[MS-RDPBCGR]: Remote Desktop Protocol: Basic Connectivity and Graphics Remoting

This topic lists the Errata found in [MS-RDPBCGR] since it was last published. Since this topic is updated frequently, we recommend that you subscribe to these RSS or Atom feeds to receive update notifications. ක<mark>ි<u>RSS</u> කි<u>Atom</u></mark>

Errata below are for Protocol Document Version <u>V8.0 – 2019/03/13</u>.

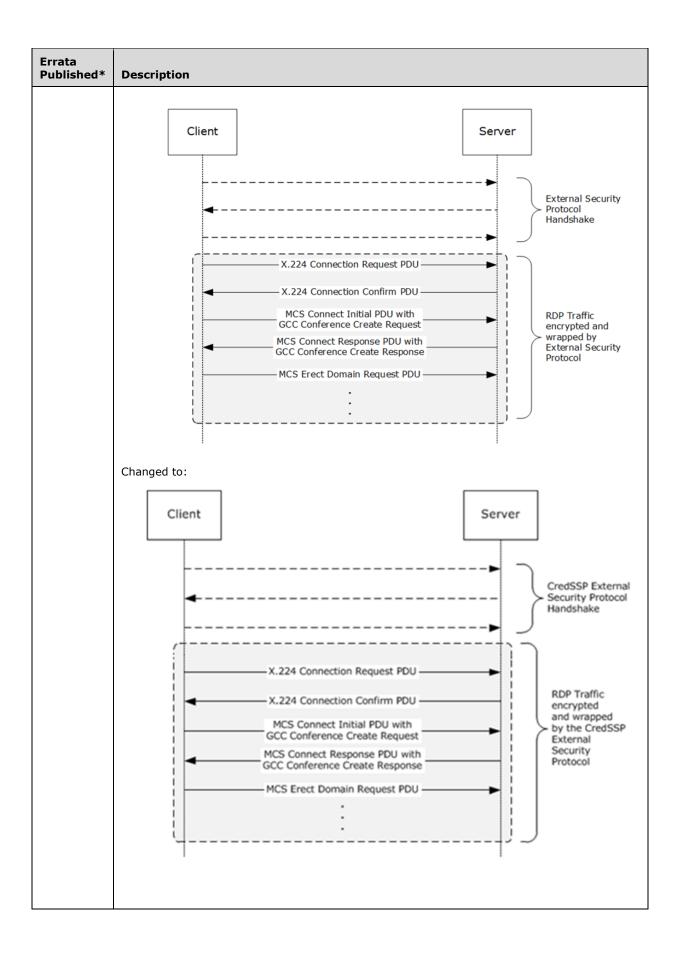
Changed to: slowPathInputData (variable): TS_KEYBOARD_EVENT, TS_UNICODE_KEYBOARD_EVENT, TS_POINTER_EVENT, TS_POINTERX_EVENT, TS_SYNC_EVENT, or TS_UNUSED_EVENT. The actual contents of the input event specified by the messageType field (sections 2.2.8.1.1.3.1.1.1 through 2.2.8.1.1.3.1.1.6).	
2020/07/06	In Section 5.4.2.2, Direct Approach, revised the figure.	
	Changed from:

Errata Published*	Description
	In that same section, changed from:
	When using the Direct Approach, no negotiation of the security protocol takes place. The client and server are hard-coded to use the Credential Security Support Provider (CredSSP) Protocol (section 5.4.5) when a connection is initiated. Once the security protocol handshake has completed successfully, the RDP Connection Sequence begins, starting with (a) the X.224 messages which form the Connection Initiation phase (section 1.3.1.1); or (b) the Early User Authorization Result PDU (section 2.2.10.2) followed by the X.224 messages. From this point all RDP traffic is encrypted using the CredSSP External Security Protocol.
	The RDP Negotiation Request (section 2.2.1.1.1) will still be appended to the X.224 Connection Request PDU (section 2.2.1.1) and the requested protocol list will contain the identifier of the CredSSP protocol (section 2.2.1.1.1). If this is not the case, the server will append an RDP Negotiation Failure (section 2.2.1.2.2) to the X.224 Connection Confirm PDU (section 2.2.1.2) with a failure code of INCONSISTENT_FLAGS (0x04). Similarly, the server will indicate that the hard-coded security protocol is the selected protocol in the RDP Negotiation Response (section 2.2.1.2.1) which is appended to the X.224 Connection Confirm PDU.

Changed to:
	When using the Direct Approach, no negotiation of the security protocol takes place. The client and server are hard-coded to use the Credential Security Support Provider (CredSSP) Protocol (section 5.4.5) when a connection is initiated. The Early User Authorization Result PDU (section 2.2.10.2) is not supported in the Direct Approach. Once the security protocol handshake has completed successfully, the RDP Connection Sequence begins, starting with the X.224 messages which form the Connection Initiation phase (section 1.3.1.1). From this point all RDP traffic is encrypted using the CredSSP External Security Protocol.
	The RDP Negotiation Request (section 2.2.1.1.1) MUST be appended to the X.224 Connection Request PDU (section 2.2.1.1) and the requested protocol list MUST contain the PROTOCOL_HYBRID (0x0000002) flag identifying the CredSSP protocol (section 2.2.1.1.1). If this is not the case, the server will append an RDP Negotiation Failure (section 2.2.1.2.2) to the X.224 Connection Confirm PDU (section 2.2.1.2) with a failure code of INCONSISTENT_FLAGS (0x04). Similarly, the server MUST indicate that CredSSP is the selected protocol in the RDP Negotiation Response (section 2.2.1.2.1) which is appended to the X.224 Connection Confirm PDU.
